Amendment 1

Amphitheater Public School AHS – 500 Wing Renovations

AMENDMENT ONE – Date: April 29, 2022

Electrical Power Plan - Demo

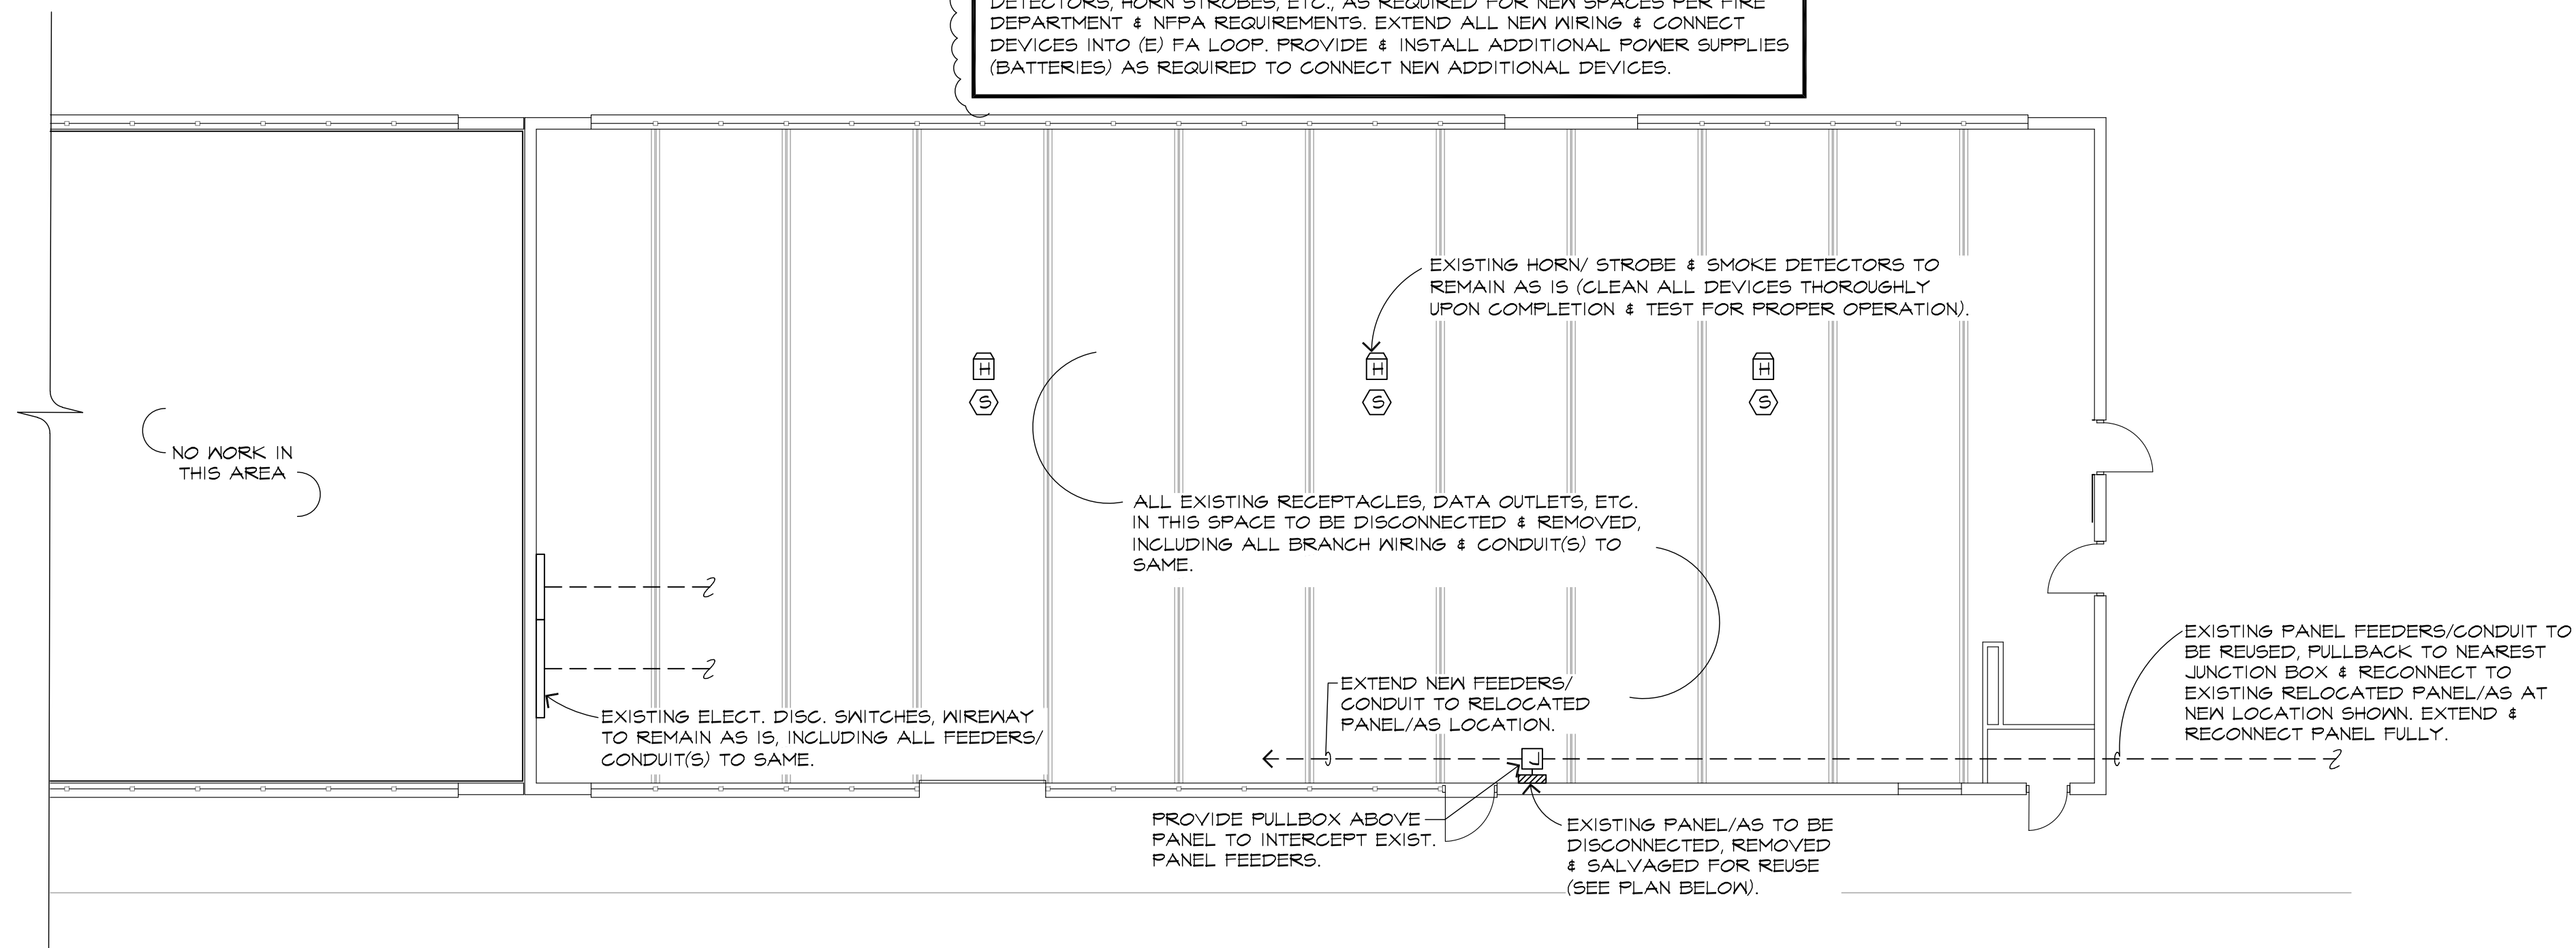
CONTRACTOR TO PROVIDE & INSTALL NEW FIRE ALARM DEVICES, I.E. SMOKE DETECTORS, HORN STROBES, ETC., AS REQUIRED FOR NEW SPACES PER FIRE DEPARTMENT & NFPA REQUIREMENTS. EXTEND ALL NEW WIRING & CONNECT DEVICES INTO (E) FA LOOP. PROVIDE & INSTALL ADDITIONAL POWER SUPPLIES (BATTERIES) AS REQUIRED TO CONNECT NEW ADDITIONAL DEVICES.
